**Project Description: \*\*Dai\*\* Building - Commercial New - 14E31A 90701 - 29300 SE HALEY RD**

**BORING - Winery storage**

**Review Comments List Date: 8/1/2023**

WORK DESCRIPTION

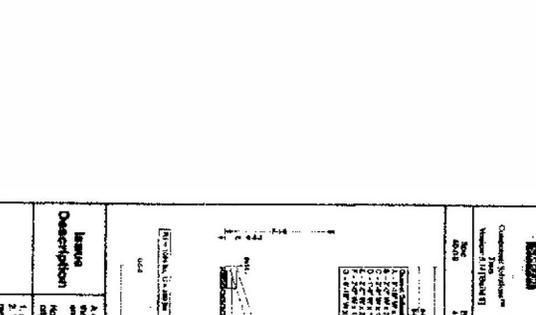
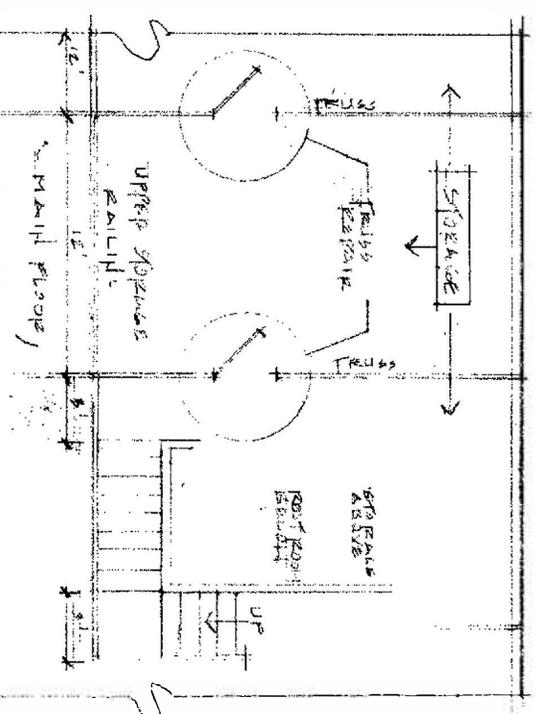
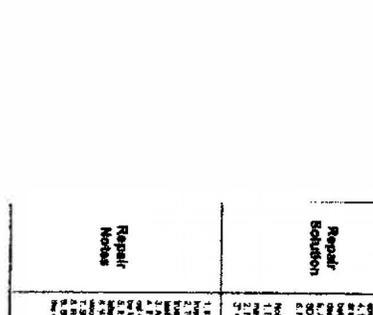
- 1 The Engineering for the cut trusses is from 4-15-2016 and the Engineer's stamp is expired. Please submit engineering for the cut trusses with Engineer's stamp that is current. (OSSC 107.2.1)

- 6 The truss repair engineering shows continuous support below the cut trusses from 0 - 20'. Please have the Engineer that provides the floor framing design address and show the continuous support below all cut trusses as required. (OSSC 1603.1)

10 Please provide a cross section at the top of the stairs to show the minimum headroom of 80" is met crossing the truss above. (OSSC 1011.3)
